From: (b)(6) .NAVFAC MIDLANT, ROICC Camp Lejeune
To: (b)(6) .NAVFAC MIDLANT, BD; (b)(6) .NAVFAC MIDLANT, Staff; (b)(6) (b) .NAVFAC MIDLANT, ROICC Camp Lejeune; (b)(6) .NAVFAC MIDLANT, ROICC Camp Lejeune
Subject: Correspondence Regarding Group III (Email 6), Freedom of Information Act (FOIA) Request DON-NAVY-2017-003161 - Camp Lejeune - P1383 & P1384 Base Entry Point / CLEO Building Projects Contract No. K1310-002-S / Project Number K1310 SLO Case No. 16-970
Date: Friday, May 12, 2017 13:27:57
Attachments: [Non-DoD Source TRANSMITTAL 1262 SPEC 27 10 00 TELECOMMUNICATIONS CABLING SYSTEM SD-03 OUTDOOR RATED CAT-6 CABLE.msg](#)
[Non-DoD Source FW INDOOROUTDOOR CAT-6 CABLE.msg](#)
[RE CAMP LEJEUNE WILSON GATE VISITOR'S CENTER - ACOUSTICAL WALL TREATMENT .msg](#)
[Non-DoD Source FW CAMP LEJEUNE WILSON GATE VISITOR'S CENTER - ACOUSTICAL WALL TREATMENT .msg](#)
[RE Transmittal 1217 REV1 SPEC 23 08 00.00 10 COMMISSIONING OF HVAC SYSTEMS SD-02 AND SD-03.msg](#)

P1383 & P1384 - New Base Entry Point and Road at MCB Camp Lejeune

From: (b)(6)
To: (b)(6) [NAVFAC MIDLANT, CI](#) (b)(6) [NAVFAC MIDLANT, ROICC Camp Lejeune](#)
Subject: [Non-DoD Source] RE: CAMP LEJEUNE WILSON GATE VISITOR'S CENTER

4
A-402A-402 FABRIC COVERED ACOUSTIC PANELS
Scale: 1-1/2" = 1'-0"

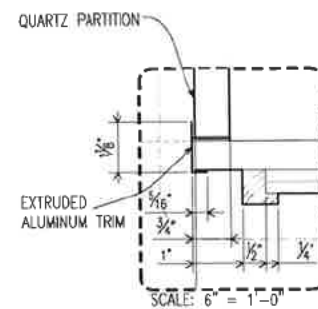
Good afternoon (b)(6). The acoustic wall panel color that was submitted and approved in the submittal is no longer available. The fabric style you proposed was a Maharam fabric style and the color was TEK-WALL view 399432; 004 glacier. The manufacturer says this color is being phased out. They don't have any leftover stock. Maharam recommends the following as alternatives.

Will you please review and select an alternate color? Thanks. R/ (b)(6)

Are any of the following available?

Tek-wall Parable 398650 #006 Value
Tek-wall Subject 399535 #003 Snowcap
Tek Wall Sum 399592 #003 Blizzard

Any of those three would be acceptable.
